Item 8: American Electric Power Service Corporation (AEPSC) Live Oak Regional Planning Group (RPG) Project

Date: October 6, 2015
To: Board of Directors
From: Jeff Billo, Sr. Manager, Transmission Planning
Subject: American Electric Power Service Corporation (AEPSC) Live Oak Regional Planning Group (RPG) Project

ERCOT Independent Review of the AEPSC Live Oak County Transmission Project

September 2015

Figure 1: Transmission System map of Live Oak County Area

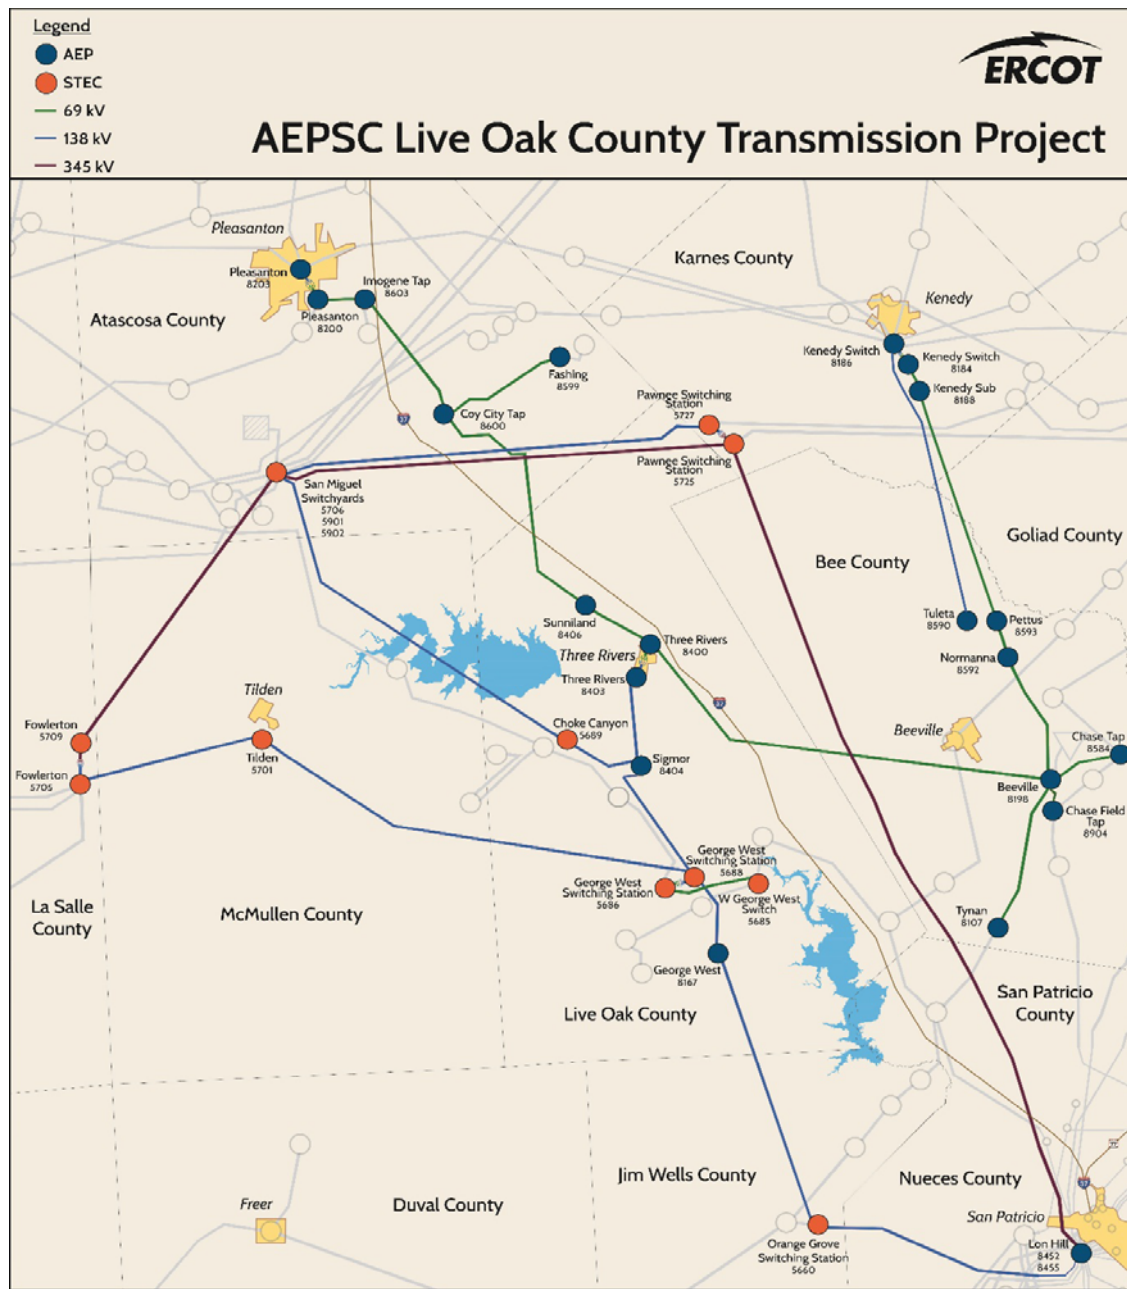
Live Oak County Texas is served by three 138 kV lines. Two of the three 138 kV lines terminate at the AEP Sigmor 138 kV Station. The two 138 kV lines are San Miguel – Sigmor 138 kV and Lon Hill – Orange Grove – George West – Sigmor 138 kV. The Sigmor 138 kV Station then serves as a source to the underlying 69 kV system through a nearby AEP Three Rivers 138 kV Station. Figure 1 shows the map of the existing transmission system in the Live Oak County area.

The load growth in Live Oak County and Bee County has recently created the need for transmission improvements in this area. In addition, with the present transmission system it is difficult to schedule the maintenance for either of the above two 138 kV lines even during off-peak seasonal conditions. In October 2013, during the maintenance outage of the San Miguel – Sigmor 138 kV line, the static shield wire of the Lon Hill – Orange Grove 138 kV line failed and faulted one of the phase conductors, causing the Orange Grove – Sigmor 138 kV line to trip and lock open. Approximately 80 MW of load loss resulted from this forced outage that included a large industrial customer and seventeen substations with load connected. Tables 1 – 3 show the reliability issues in the study area.

Based on the review, ERCOT recommends Option 4 as the preferred option to meet the reliability need in the area. The following facilities constitute the preferred option:

- Construct a new 138 kV Beeville Substation near the existing Beeville 69 kV Station
- Install a new 138/69 kV autotransformer at the new Beeville 138 kV Station with an emergency rating of approximately 143MVA
- Construct a new 138/69 kV double circuit transmission line from Tuleta to Beeville with emergency ratings approximately 360/180 MVA. Attempt to utilize existing Right of Way of the Pettus – Normanna – Beeville 69 kV transmission line where possible
- Using existing Right of Way where possible, rebuild and convert the existing Beeville – Three Rivers 69 kV transmission line to 138 kV with an emergency rating of approximately 360 MVA
